## Sumner Flood Modelling

### TUFLOW HPC Model Build Report

## SUMNER FLOOD MODELLING – MODEL BUILD REPORT

| VERSION | DATE       | DESCRIPTION                                                                                               | AUTHOR              | REVIEWED    |
|---------|------------|-----------------------------------------------------------------------------------------------------------|---------------------|-------------|
| 3.0     | 8/8/2025   | Model build report after CCC comments on inclusion of irregular culvert and CCC filename and conventions. | Chusit Apirumanekul | Brad Scarfe |

Figure 4. TUFLOW model extent with boundary conditions (RORB flows and tidal boundary).

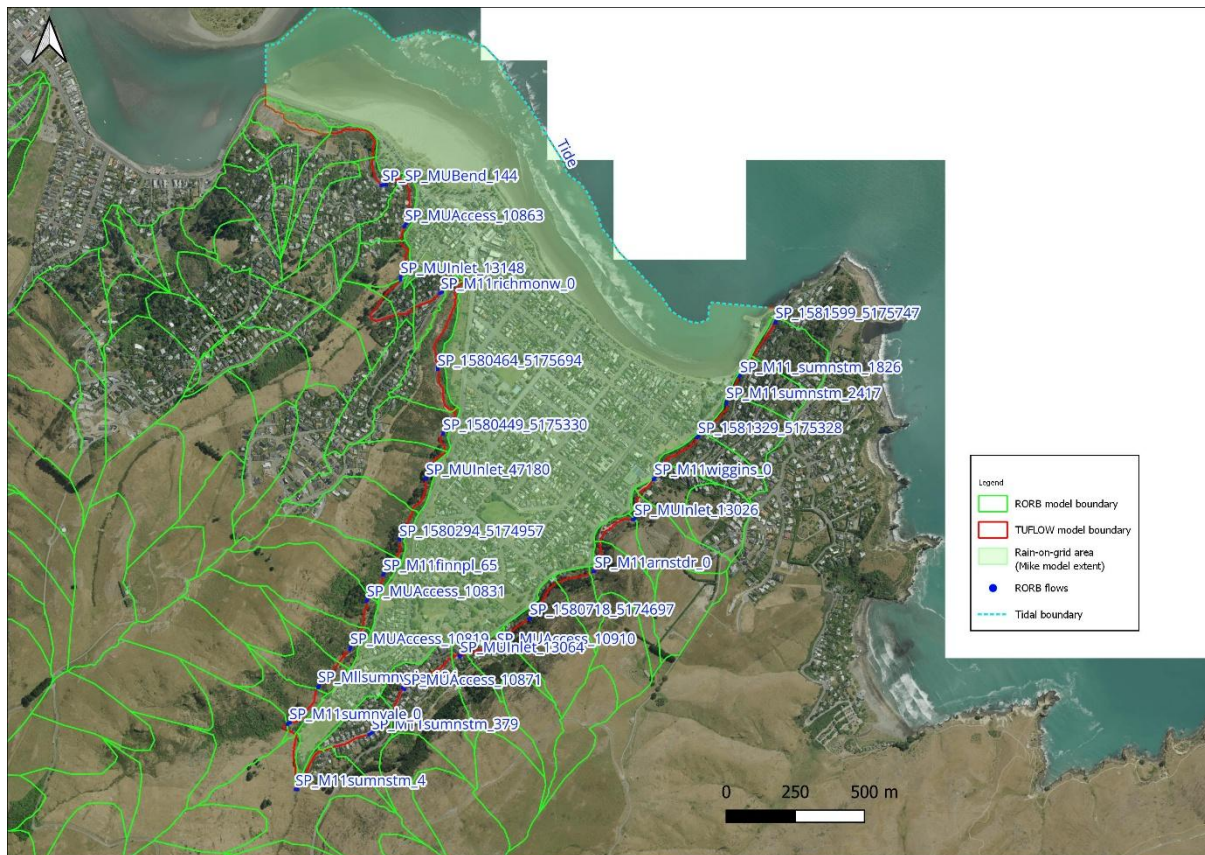
models were attached to the TUFLOW model boundary in the 2D domain. Therefore, RORB flow connections and the TUFLOW model extent were adjusted to ensure that generated RORB flows can enter the stormwater networks. Figure 4 shows the TUFLOW model extent, and the updated RORB flow connections and sub-catchment boundaries. Appendix A summarizes the modifications of RORB flow locations and TUFLOW model extents based on peer review and CCC feedback.

## APPENDIX A - MODIFICATION OF RORB FLOW CONNECTIONS

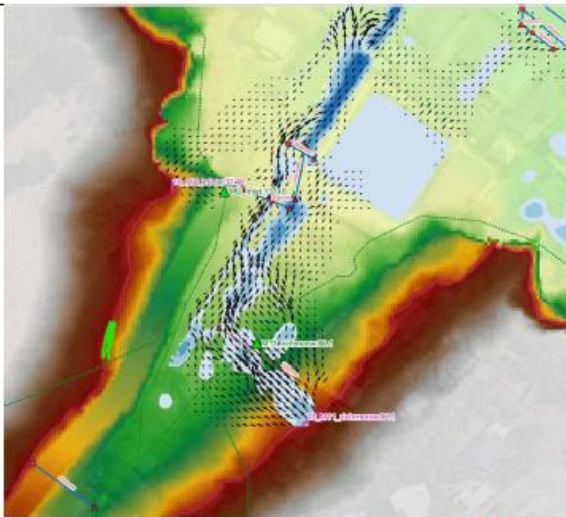
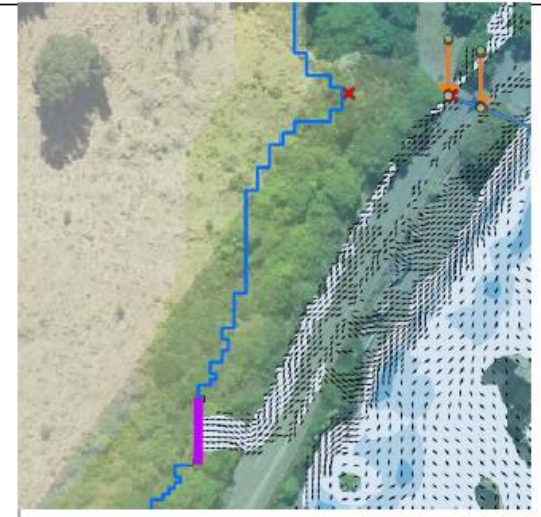
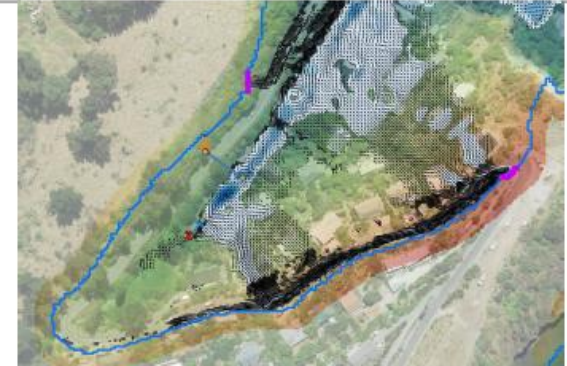
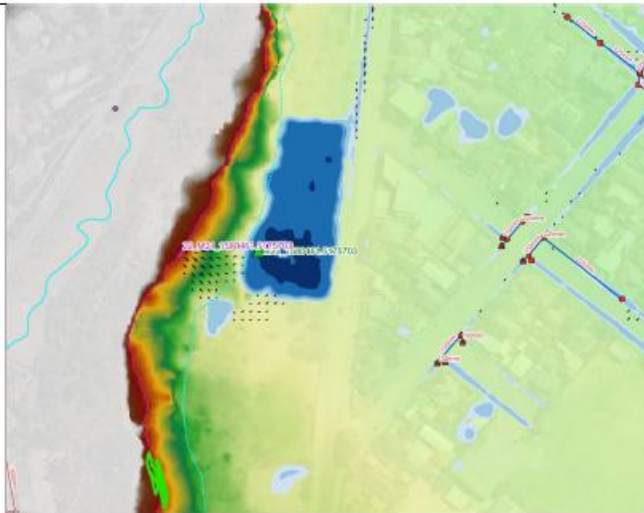
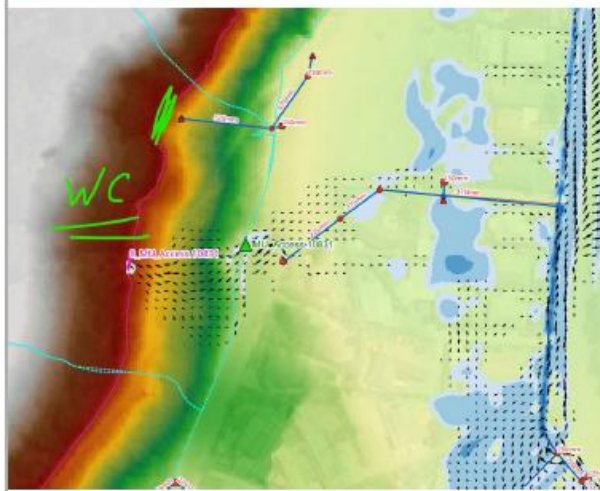
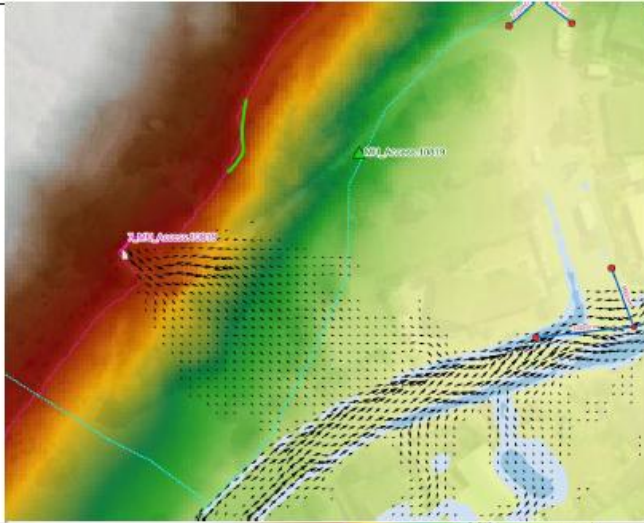
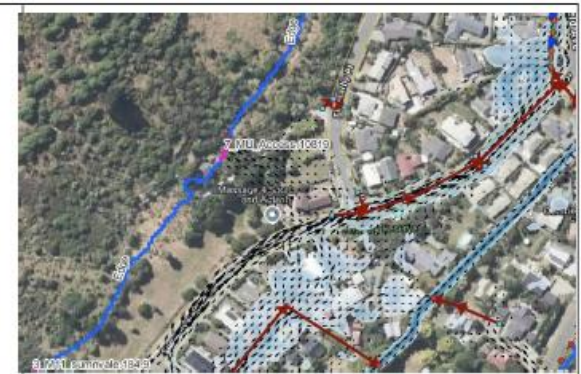
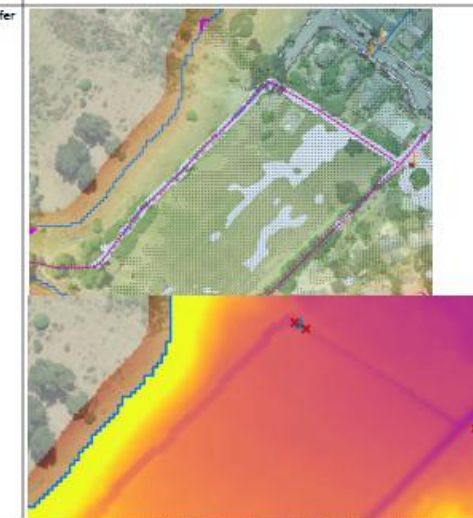
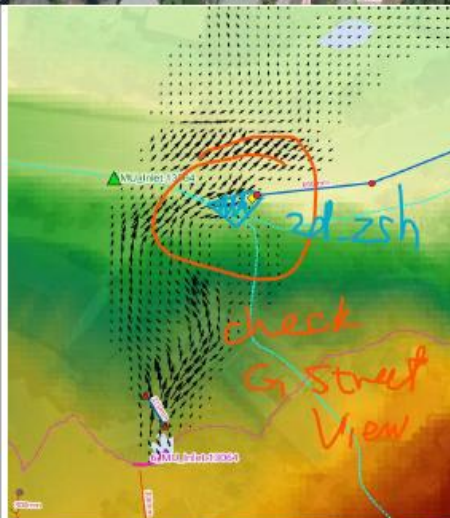
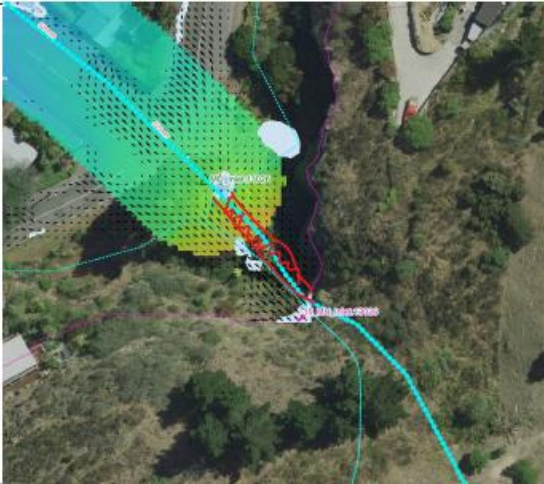
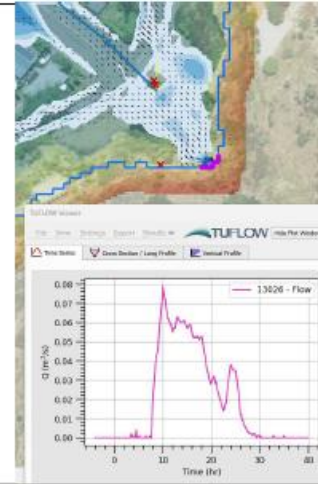
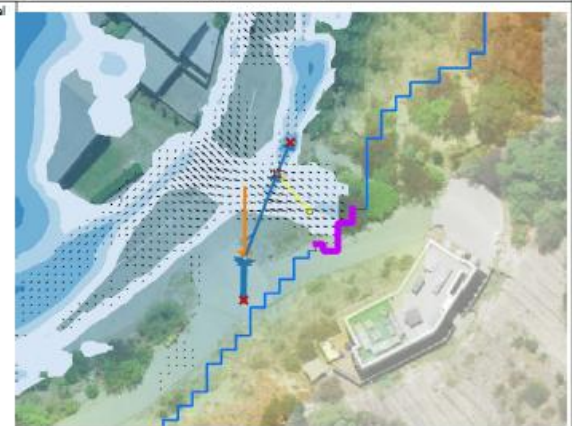
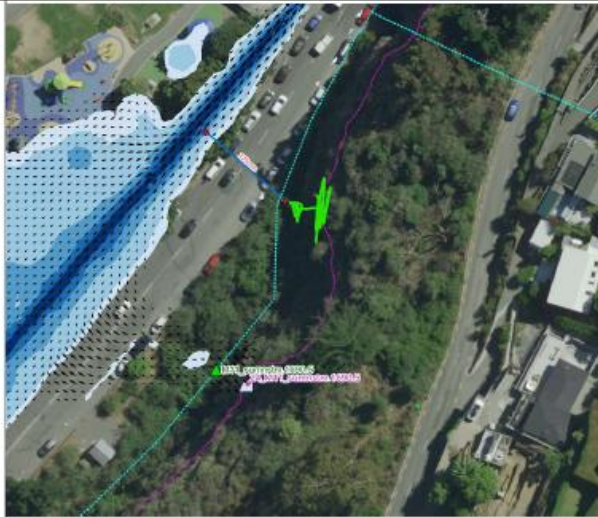
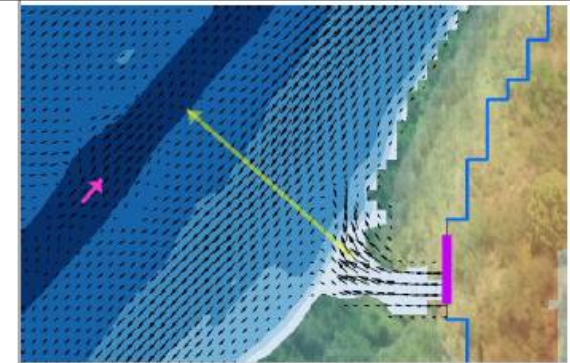
Move flow boundary to green line to let flow follow the street.

Extend model boundary (blue line) following the street terrain.

Mode flow boundary to green line to let flow follow the street terrain.

Move flow boundary to green line to let flow follow the terrain and let's see if it fill the pond.

Move flow boundary to green line to let flow follow the water course (stormwater network in this case). FYI, watercourse include drain and stormwater network).

Move flow boundary to green line to let flow follow the terrain.

Include watercourse (thick dotted pink line) in the terrain using 2d\_zsh. Refer to email for details of watercourse.

Move flow boundary to green line to let flow follow the street terrain.

Move flow to green line to let flow follow the street.

There is a structure (little yellow polygon) at the pit (red square) to collect flow to the SW network. Add 2d\_zsh to modify the terrain to ensure that the flow is collected to the SW network.

Check which RORB upstream catchments were included for flow at M11\_armstdr.0. See if flows should be separated (by area ratio) for flow at the watercourse. See attach emf file for RORB details.

Check if watercourse is included in the terrain. Chusit to check reclassified LIDAR. If not, include 2d\_zsh (red lines).

Change manhole (red circle) to pit to ensure that it collect flows from external catchment.

Move flow boundary to green line.

Move flow to green line to let flow be collected at inlet (red triangle).

Figure 5 Investigation of high velocity in the coastal area

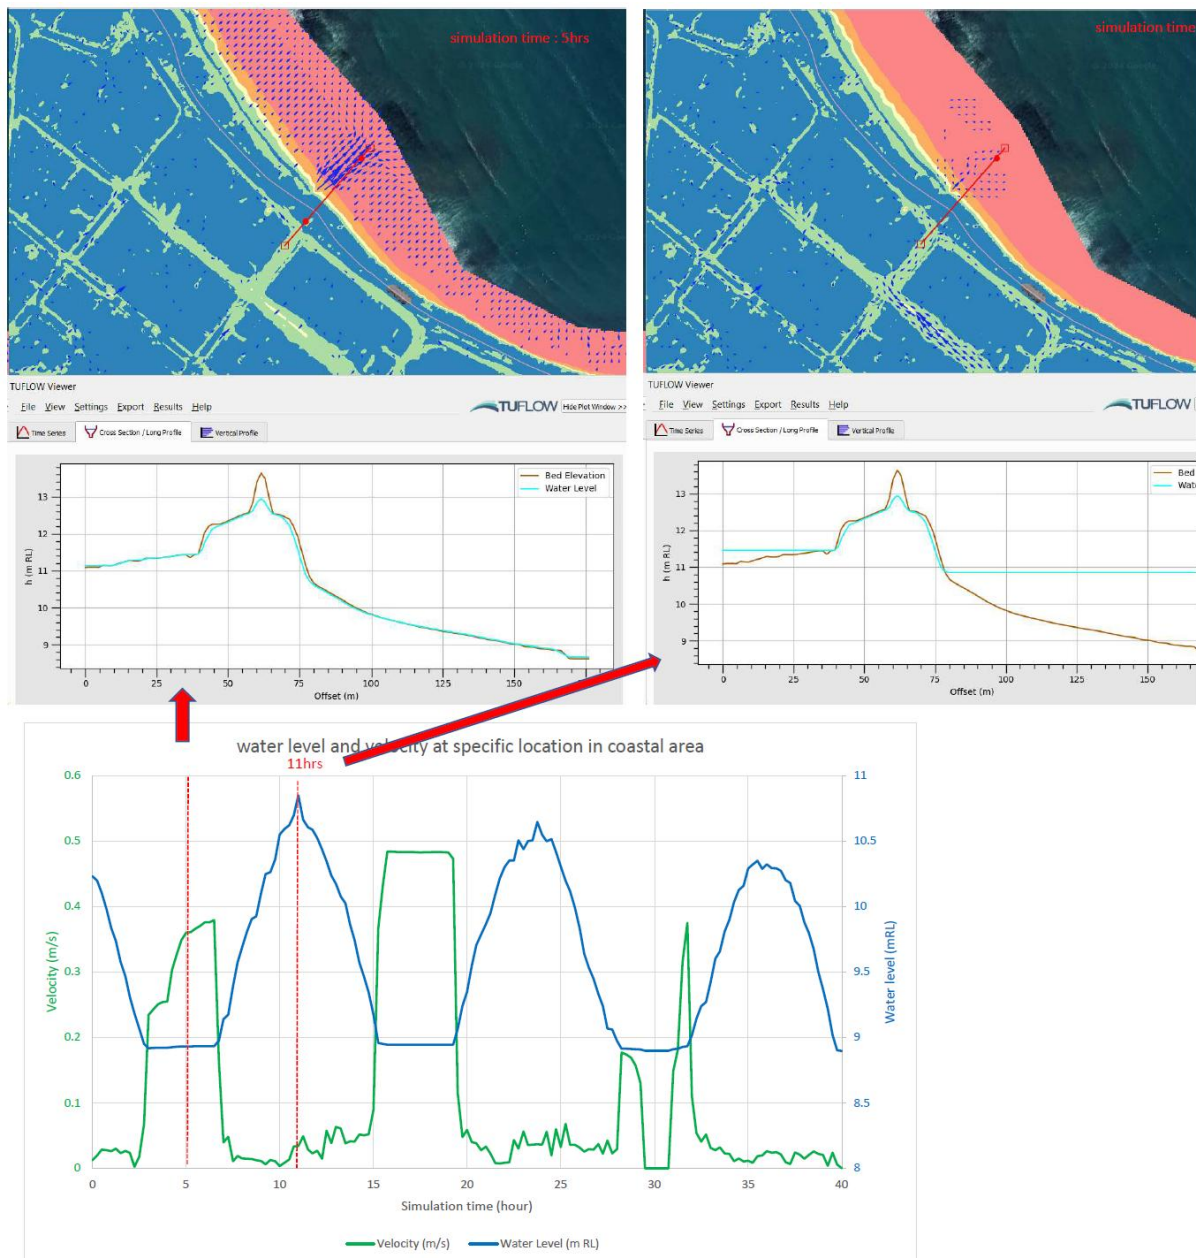
|                             |                                                                                                                                                                                           |  | We checked possible causes of high velocities at the coastal area. Roughness value of 0.025 is set for coastal area. It is found that high velocities occur when tidal level is low (Figure 5). Slope of the bathymetry is around 2%. During low tide, high velocity in the coastal area could be expected due to low roughness and the geometry of the sea bed slope. This is likely to have insignificant impact to the onland floodings due to high elevation of road with sea wall along the road.                                                                               |  | No further action.                                                            |

Figure 6 Difference in water depth (raised 150mm over buildings with  $n = 0.02$  minus by original DEM with  $n = 0.2$  over buildings) under March 2014 event

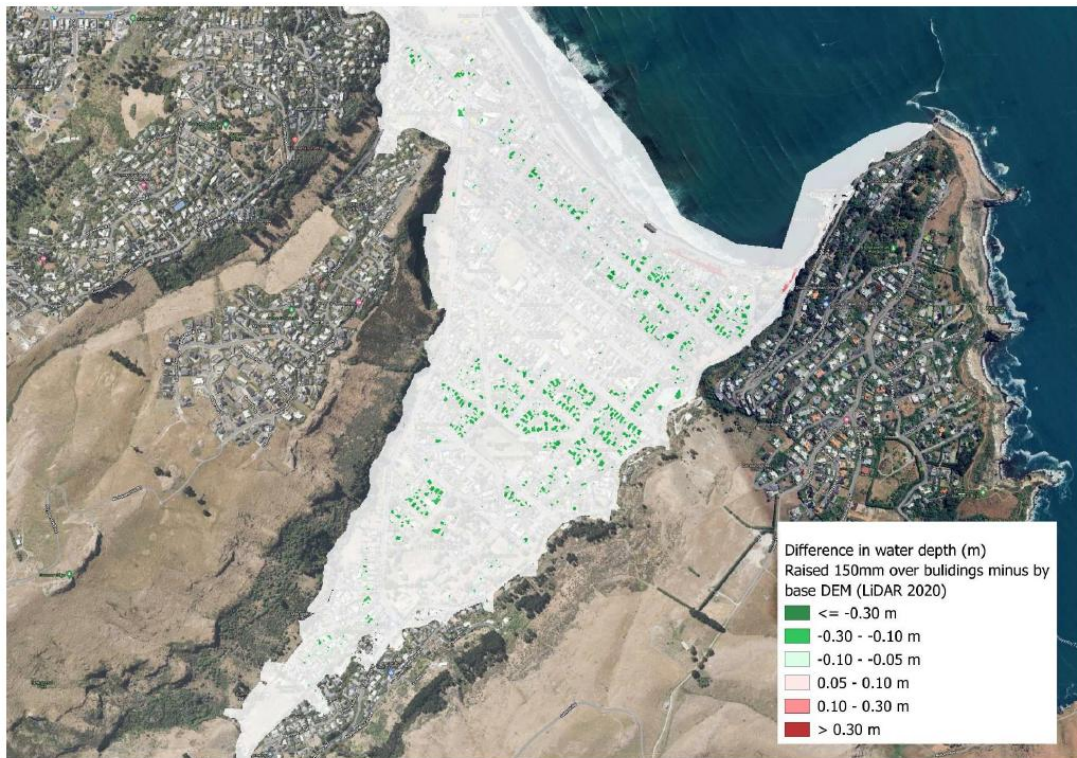
|                             |                                                                                                                                                                                           |  | Some results for sensitivity tests suggested by peer reviewers are included in the 'Figure' spreadsheet.<br><br>DHI model has an instability issue when using the raised ground elevation to represent building footprints. CCC suggested to do a sensitivity test on modelling of buildings (high roughness $n = 0.2$ for buildings vs raised elevation by 150mm with lower roughness $n = 0.02$ ) using TUFLOW model. Simulations for both approaches are similar without instability issue. Figure 6 shows flood depth difference map for sensitivity test on building roughness. |  |                                                                               |
